OBD DEMONSTRATION PROCEDURE FOR MALFUNCTIONS WHICH CAUSE DEFAULT ACTION WITH INCREASED EMISSIONS INCL. ACEA&CLEPA PROPOSAL_V2 FOR MODIFICATION (SLIDES 10-13)

UN Regulation No. 83, Suppl.8 to 07 [28.05.2019] → ACEA&CLEPA PROPOSAL

OBD certification demonstration – example oxygen sensor

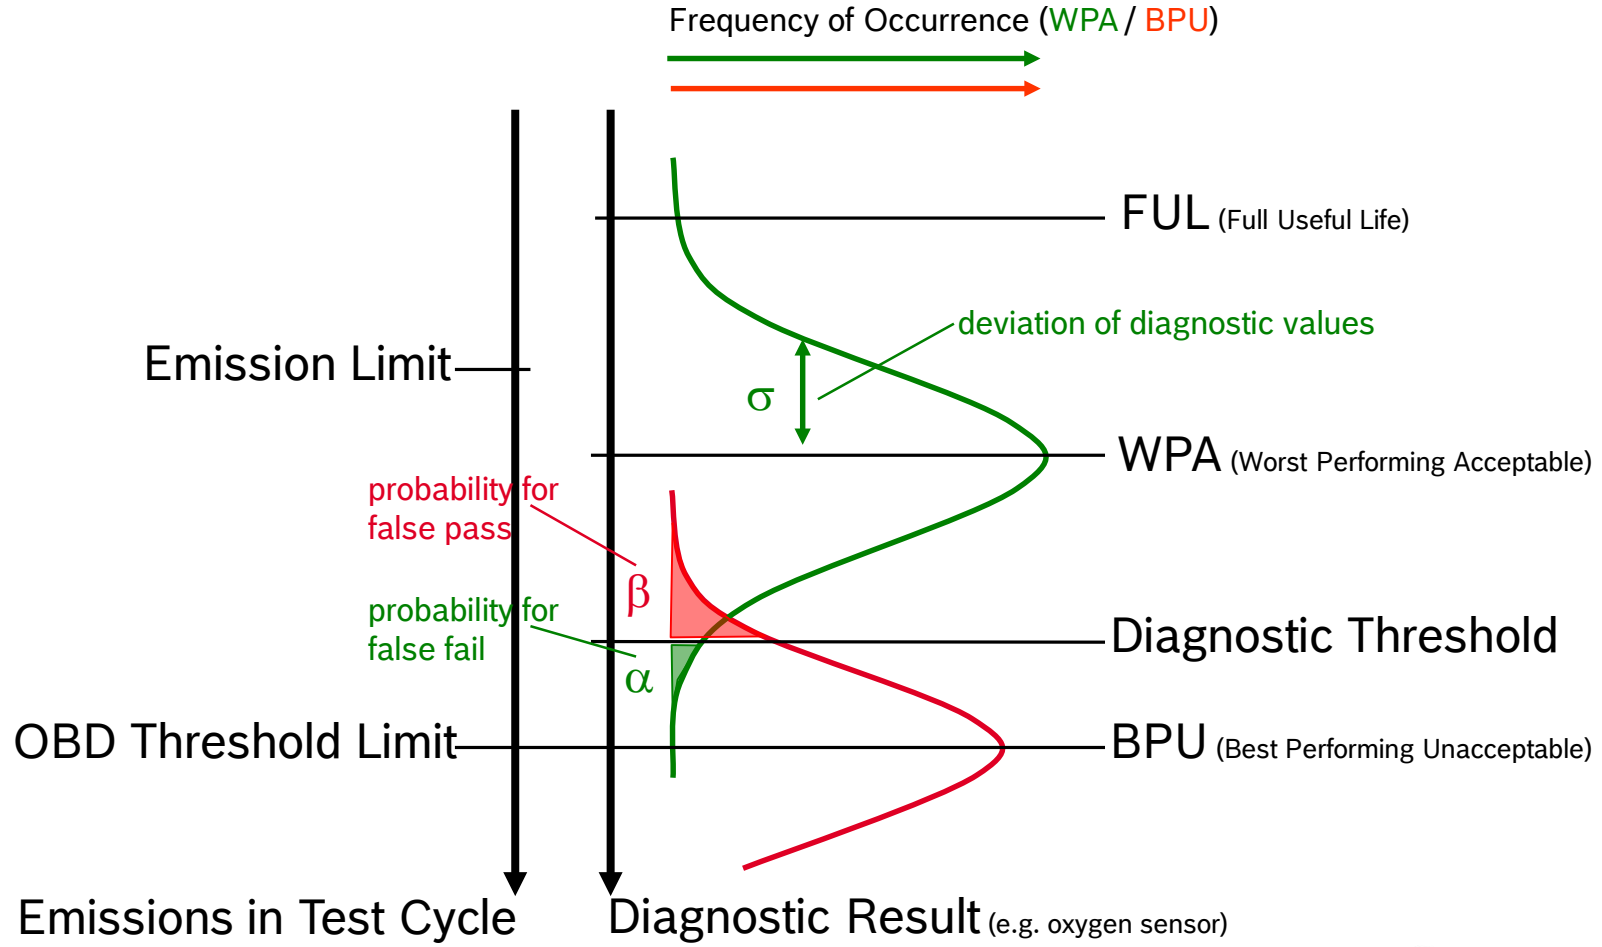
- ▶ After implementation of a faulty oxygen sensor with the fault size as needed for OBD certification demonstration (i.e. to the best performing unacceptable (BPU) level for detecting the malfunction & storing a fault code & illuminating MI), the default action will cause the emissions to exceed OBD threshold limits significantly

- not acceptable without any *countermeasure* (possible countermeasure: see below)
- ▶ An oxygen sensor which has deteriorated to the worst possible level, which will not cause malfunction detection & storing a fault code & illuminating MI (i.e. to the worst performing acceptable (WPA) level), would not cause emissions to exceed OBD threshold limits.

- ▶ Possible *Countermeasure* (in alignment with CARB OBD II):
 - ▶ Re-testing with reduced fault size (i.e. to the worst performing acceptable (WPA) level), such that no malfunction detection & no storing a fault code & no illuminating MI will happen
